FINAL DECISION
Energex determination 2015–16
to 2019–20

Attachment 6 – Capital
expenditure

October 2015

Figure 6.1 Energex's total actual and forecast capex 2010–2020

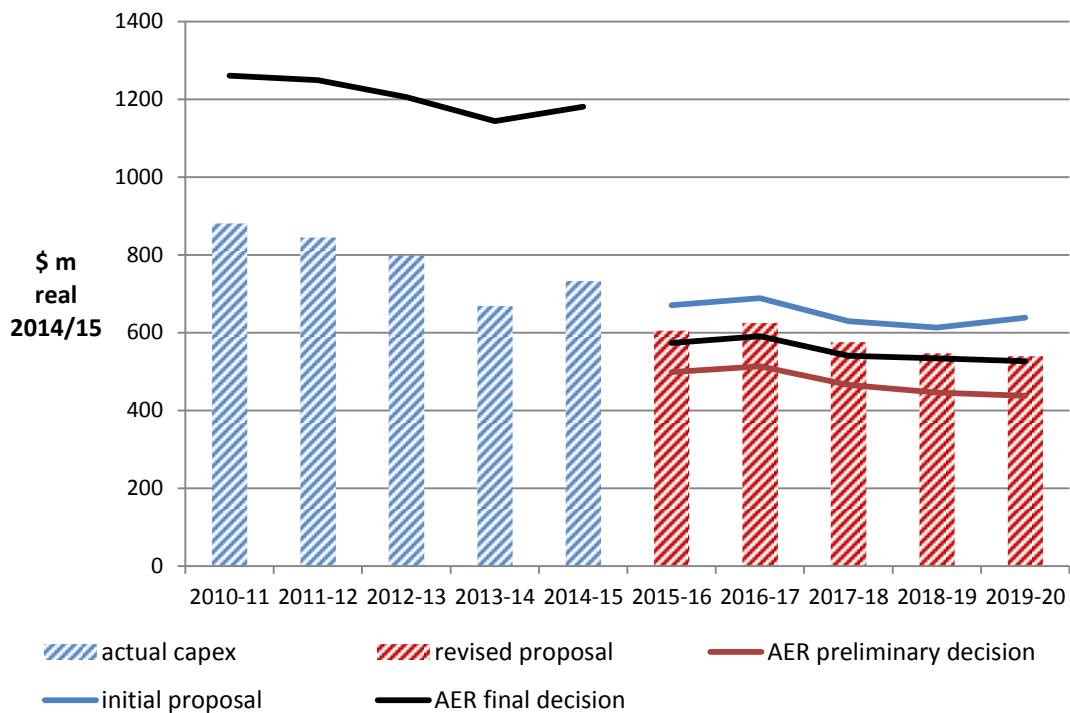
Figure 6.1 shows the difference between Energex's initial proposal, its revised proposal, and our preliminary decision for the 2015–20 regulatory control period, as well as the actual capex that Energex spent during the 2010–15 regulatory control period.

Figure 6.2 Partial factor productivity of capital (transformers, overhead and underground lines)

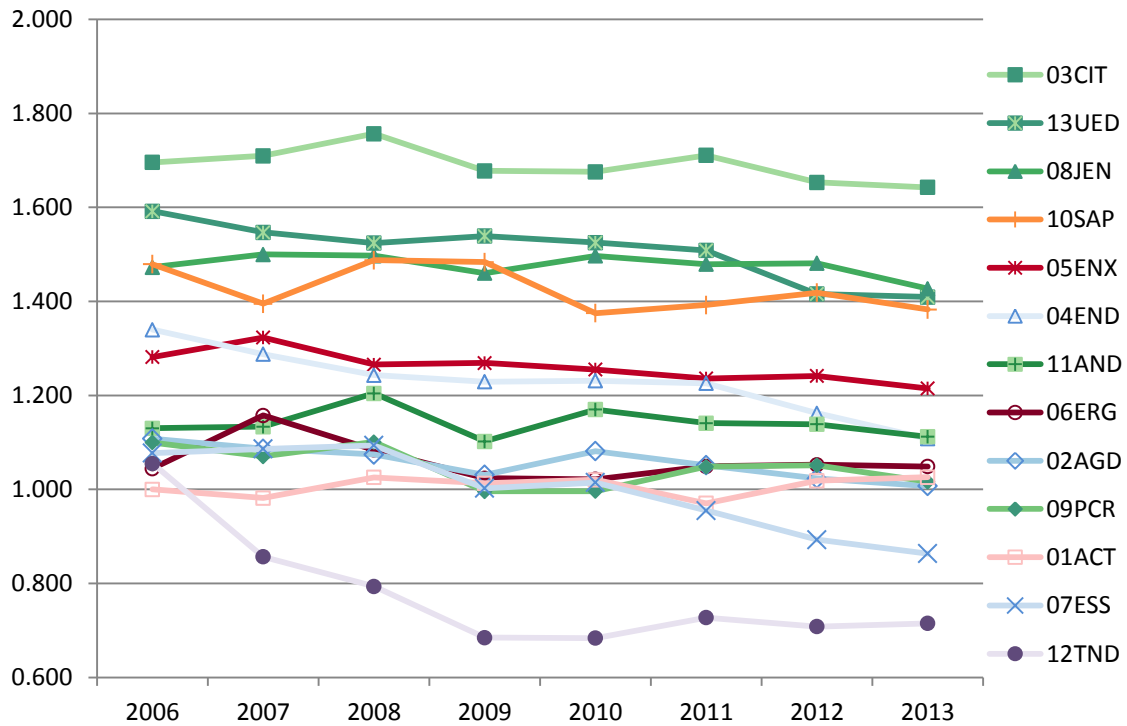
Figure 6.2 shows a measure of partial factor productivity of capital taken from our benchmarking report. This measure incorporated the productivity of transformers, overhead lines and underground cables. Energex falls in the middle of the range on this assessment, falling behind some of the Victorian and South Australian distributors.

Figure 6.3 Multilateral total factor productivity

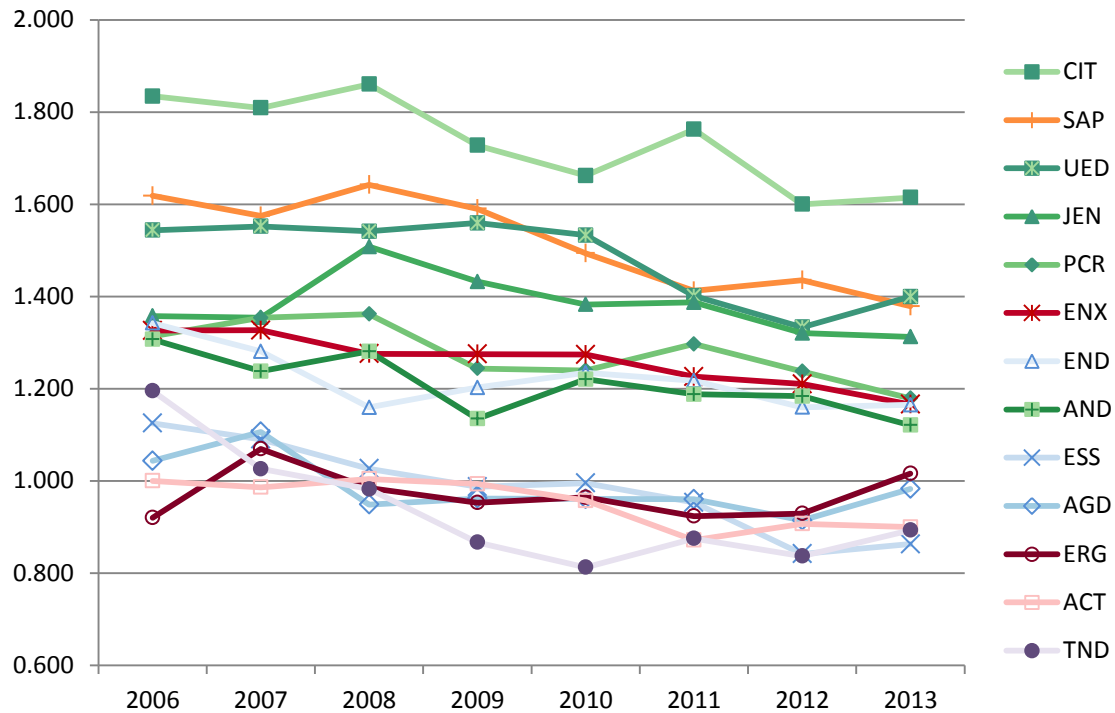
Figure 6.3 shows that Energex ranks similarly on MTFP. MTFP measures how efficient a business is in terms of its inputs (costs) and outputs (energy delivered, customer numbers, ratcheted maximum demand, reliability and circuit line length). Across all of these measures, Energex outperformed the NSW and ACT distributors; however the majority of the Victorian and South Australian distributors outperformed Energex.

Figure 6.4 Capex per customer (000s, \$2013–14), against customer density

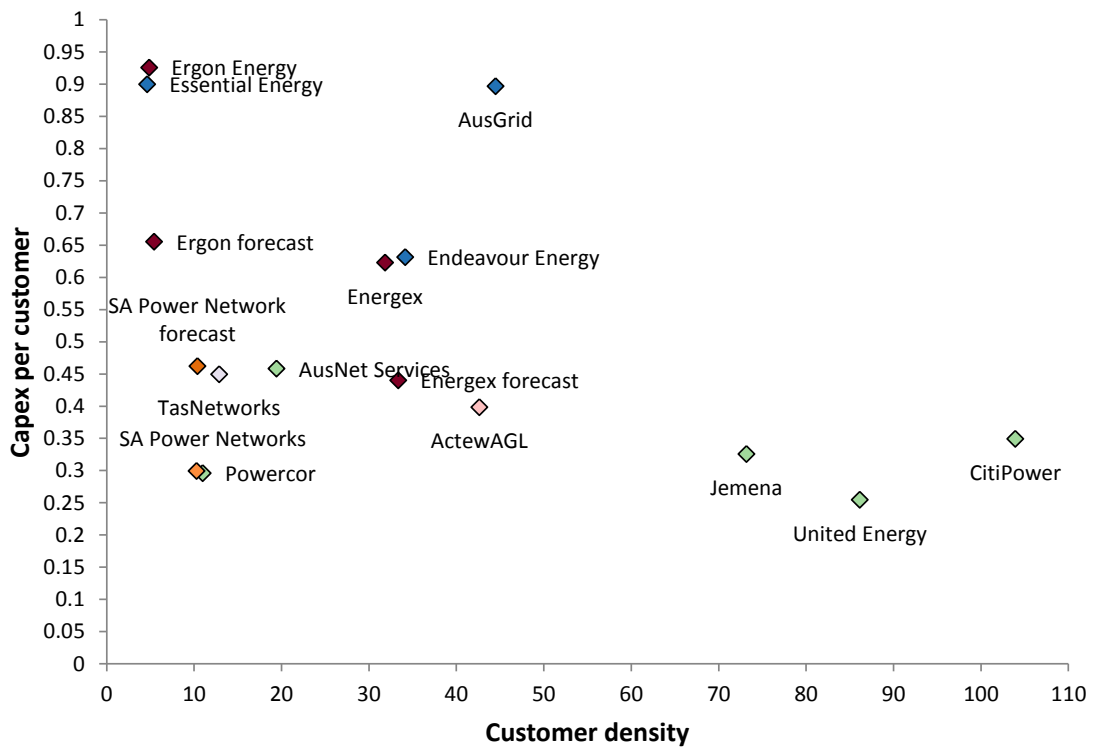
Figure 6.4 shows that Energex had relatively high capex per customer for the 2008–2012 period when compared to its peers. Energex's capex per customer will decrease for the 2015–20 regulatory control period based on their proposed forecast capex. This reduction brings Energex's capex per customer to a similar level as the Victorian and South Australian distributors.

Figure 6.5 Capex per maximum demand (000s, \$2013–14), against customer density

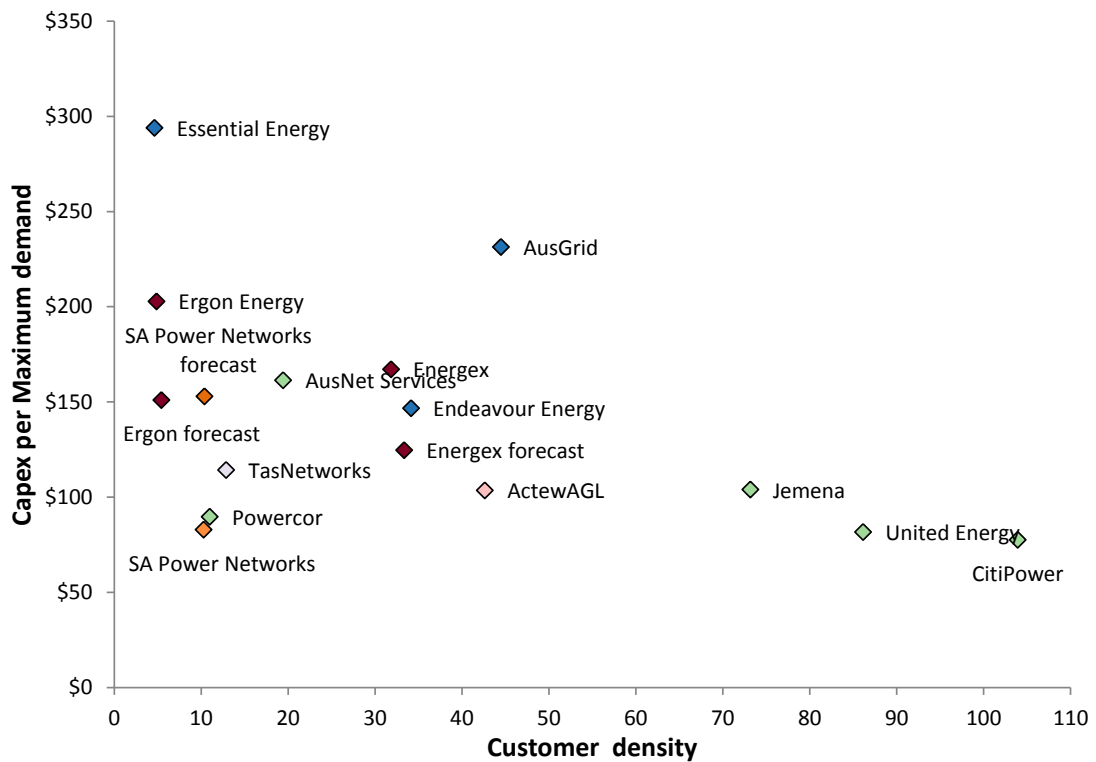
Figure 6.5 shows that Energex's capex per maximum demand for the 2008–2012 period was relatively high, but significantly lower than some NSW distributors. Capex per maximum demand is forecast to reduce for Energex in the next period.

Figure 6.6 Energex total capex – historical and forecast 2002–2020

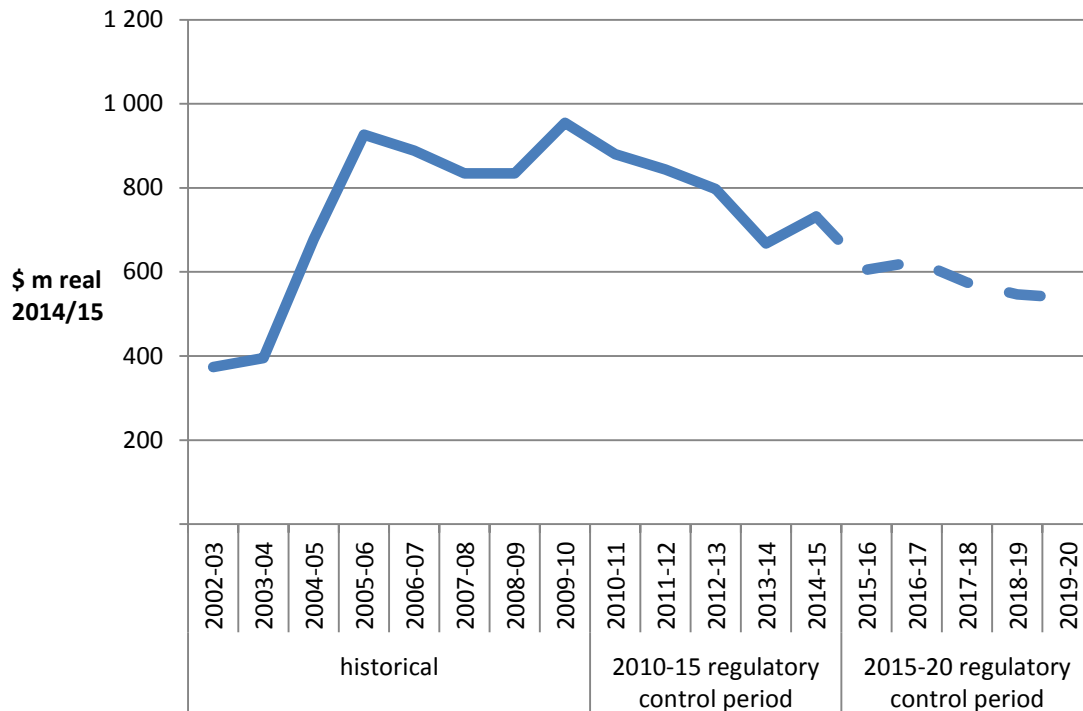
Figure 6.6 shows actual historic capex and proposed capex between 2002 and 2020. This figure shows that while Energex’s average proposed capex for the 2015–20 regulatory control period is lower than the previous regulatory control period, it is still a substantial increase over the early 2000’s.

Figure B.1 Zone substation forecast utilisation 2014–15 to 2019–20 (without additional augmentation)

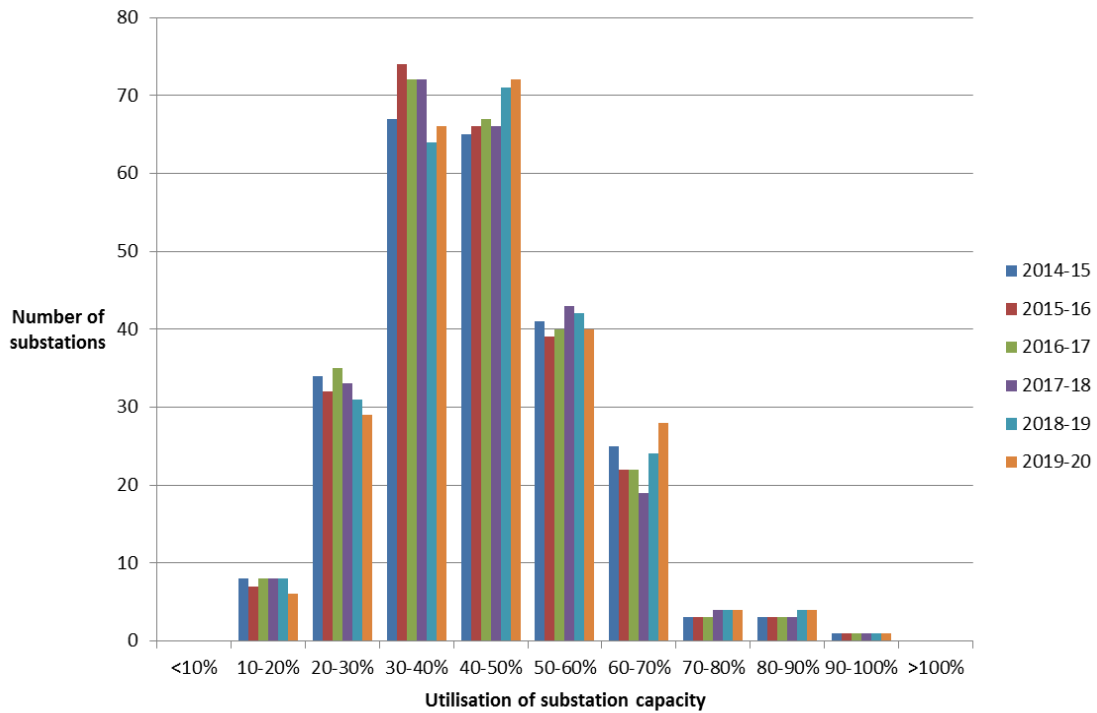
- Energex's forecast network utilisation at each zone substation shows that the majority of Energex's substations are not forecast to be highly utilised over the 2015–20 period. While a small number of zone substations are forecast to operate at between 80 and 90 per cent of capacity in 2020, it was not clear that this supported the overall level of augex Energex proposed. This is evident in Figure below, which shows that Energex expects that the vast majority of its zone substations will operate below 70 per cent of its capacity by 2020 (in the absence of augmentation).

For this assessment we looked at forecast network utilisation at the zone substation level which gave us an indication of whether there were forecast localised capacity constraints over the 2015–20 period. This is shown in Figure , which shows that only a few zone substations are expected to be highly utilised by the end of the 2015–20 regulatory control period. While this suggests that some augmentation may be justified

Figure B.3 Low Voltage Fuse Retrofits to Pole Transformers per annum

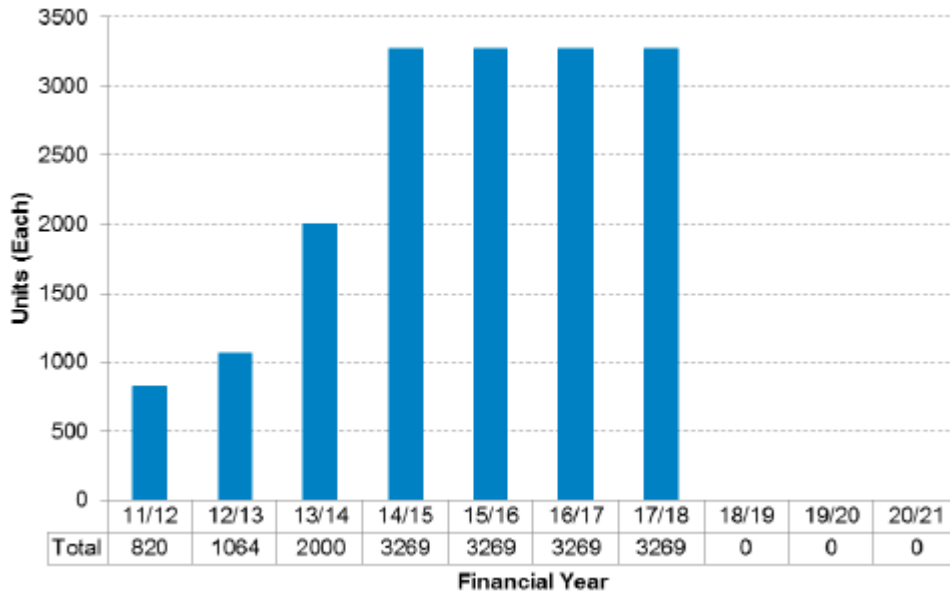
In 2012–13 a further review was undertaken by Energex that suggested that the retrofit program should be completed within a “reasonable” timeframe. In practice, Energex took this to mean that they should complete the work within 10 years of the ENA guideline publication. As shown in figure B.3, this led to a ramp-up of volumes. By the

Figure B.4 11kV Wildlife Events

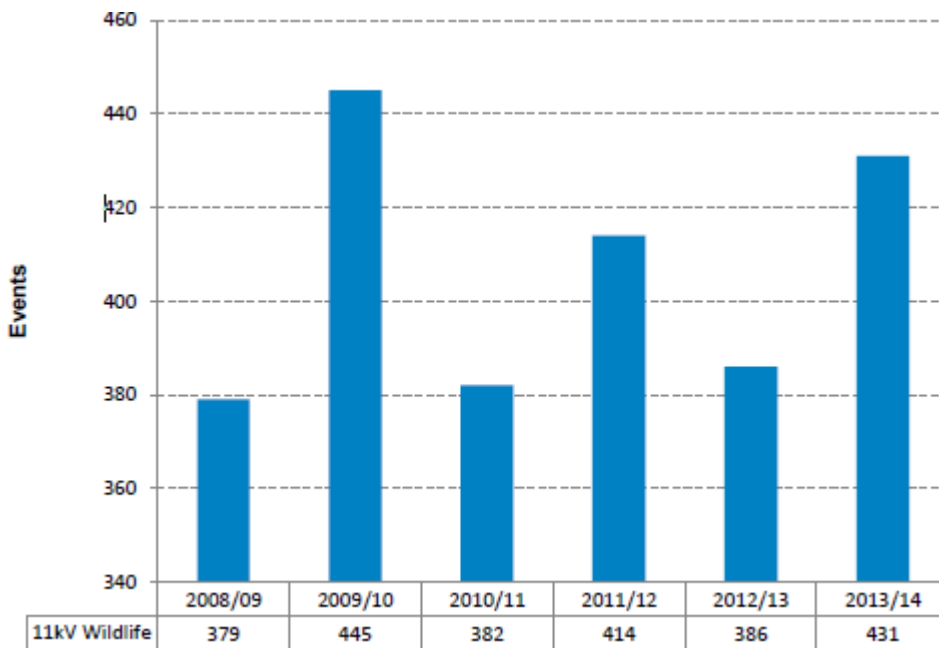
To assess the reasonableness of the forecast associated with wildlife proofing we have had regard to the trends in the number of events on the electricity network being caused by interference from wildlife. As shown in Figure , the number of wildlife events on the network has not shown any particular trend. We consider that Energex’s forecast that holds expenditure constant on this small program from actual levels recorded since 2013–14 is reasonable given the lack of trend in the number of wildlife events.

Figure B.5 Number of Network Incidents Causing Fire

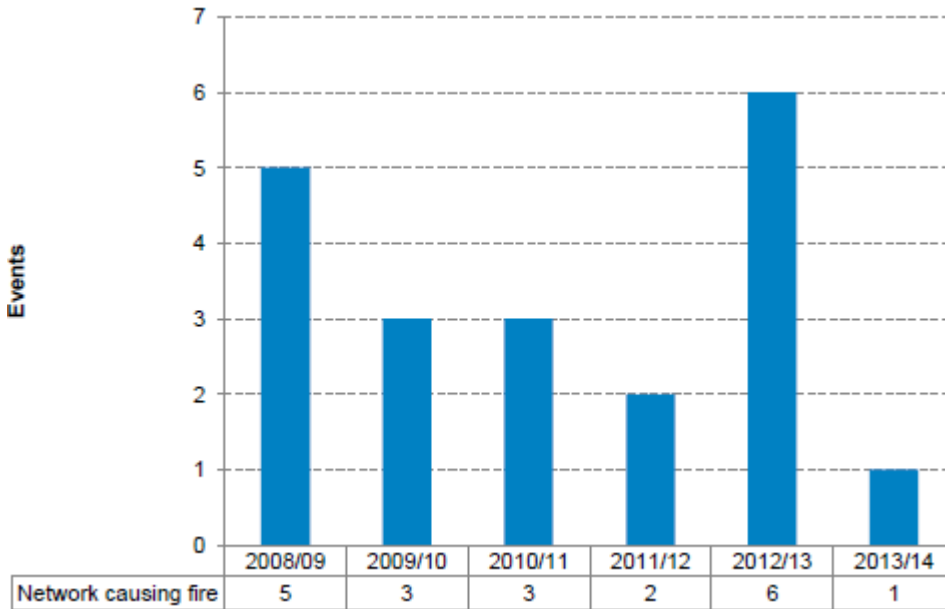
To test the reasonableness of the bushfire component of this forecast, we have had regard to the number of network incidents that have caused a fire. Figure shows that the trend in the number of fires cause by network incidents has been declining since 2008–09, apart from 2012–13.

Figure B.6 Brisbane River highest annual flood peaks at city gauge

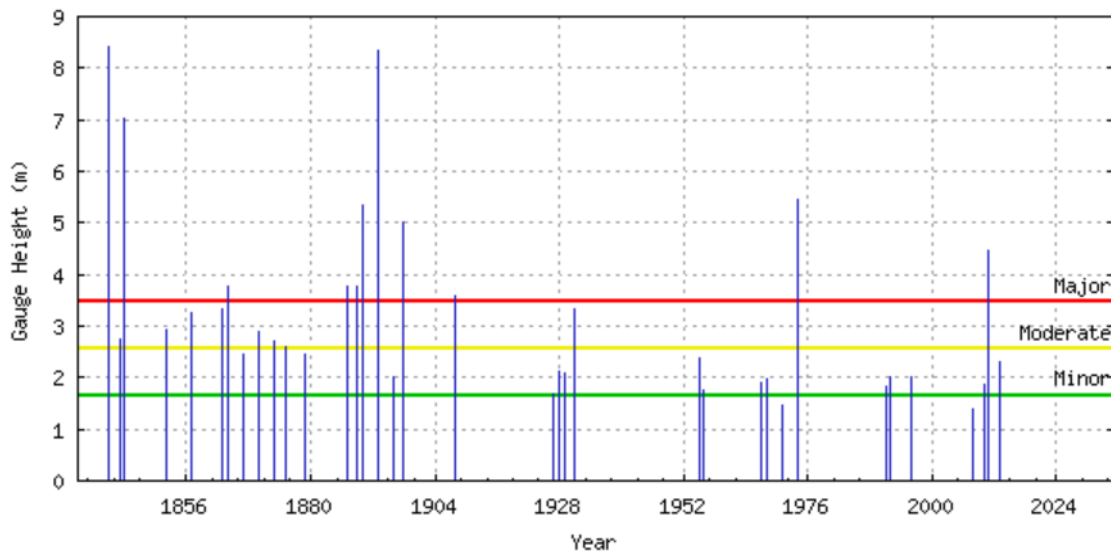
To assess the need for this program, we have had regard to Brisbane River flooding data from the Bureau of Meteorology. As Figure shows, apart from the major flooding that occurred in 2011, moderate level flooding is a very rare occurrence and has not been recorded since the Wivenhoe Dam was completed in 1984. The 2013 flooding associated with ex-tropical cyclone Oswald was the most significant since the dam was completed. However, Energex note that only minimal numbers of assets were inundated during this event, with most customer outages caused by high winds and falling trees.⁹⁷

Figure B.7 Neutral Related Shock Complaints

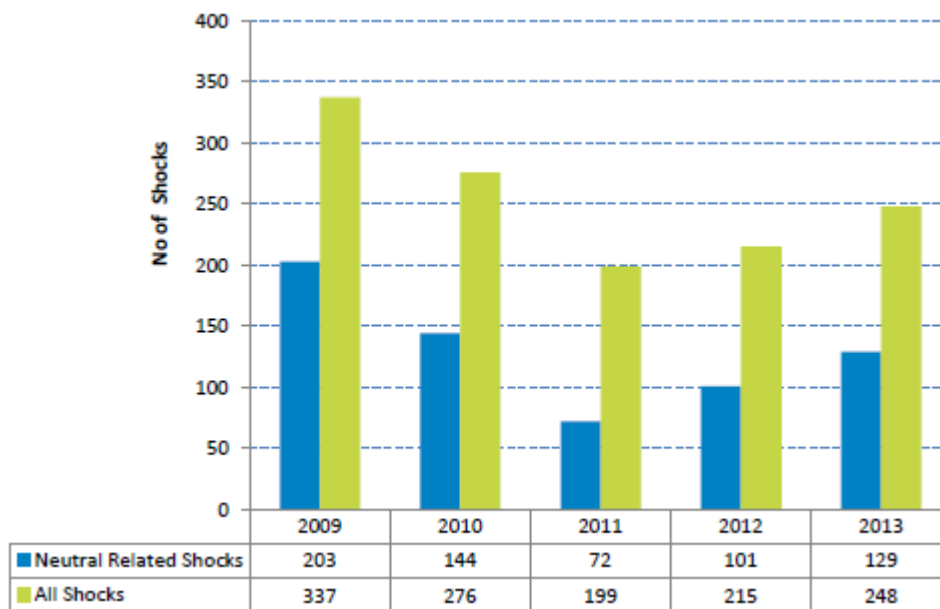
As shown in Figure , since 2009 neutral related shock complaints had been consistently falling until 2012 and 2013 which recorded increases.

Figure B.8 Neutral related Insurance Claims

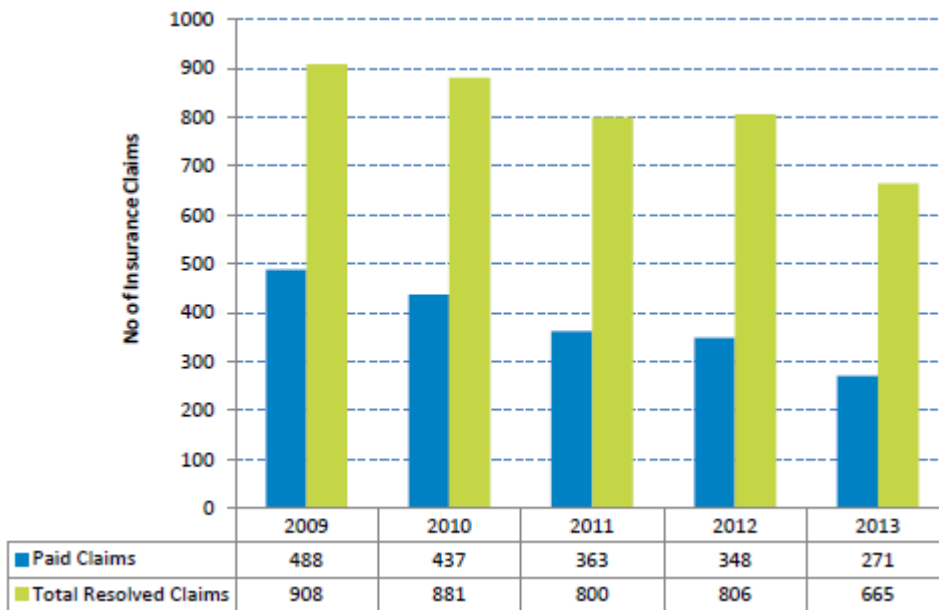
However, as shown in Figure , neutral related insurance claims (paid and resolved) have continued the same downward trajectory from 2009 onwards. We consider that the better indicator of trends in neutral related issues is the trend in insurance resolved claims. This is because they represent verified incidents of issues with neutral connection failures, whereas the ultimate cause and resolution of complaints is unclear.

Figure B.9 Energex forecast - low voltage augex – minor works (\$2014–15)

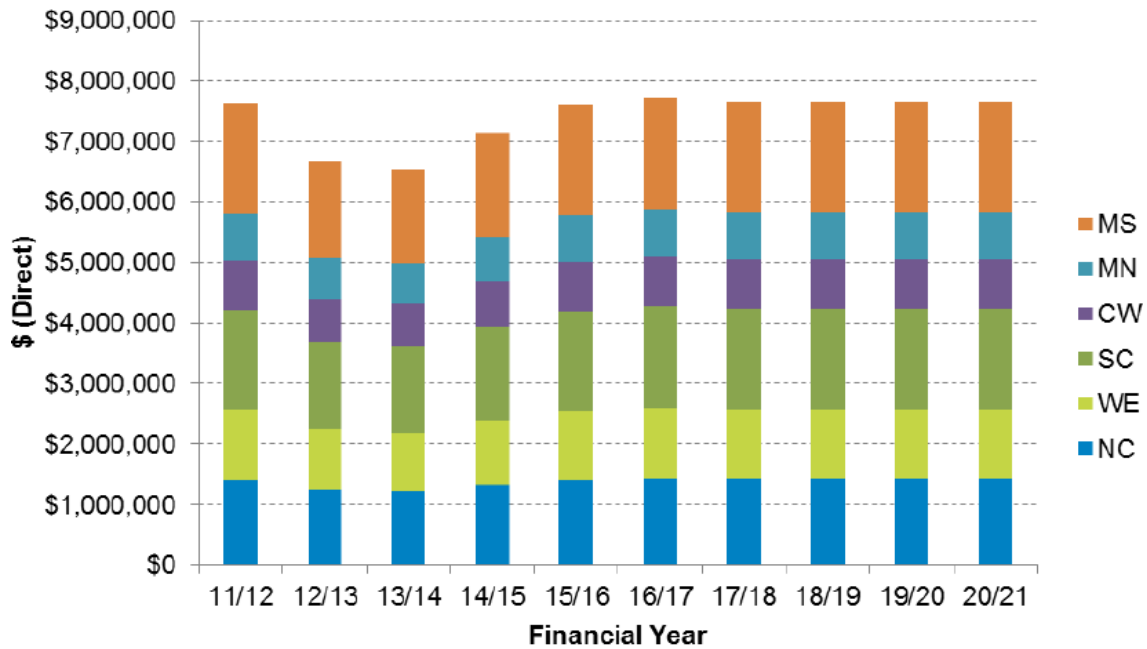
As shown in Figure , expenditure in low voltage augex – minor works has been decreasing since 2011–12. The expenditure shown from 2014–15 onwards are forecasts proposed by Energex. The step-up in expected expenditure has not been explained by Energex. For example, we have not observed in the information provided in Energex’s original proposal, its revised proposal or information received in response to information requests, evidence of trends in customer complaints or other incidents that drive this form of expenditure.
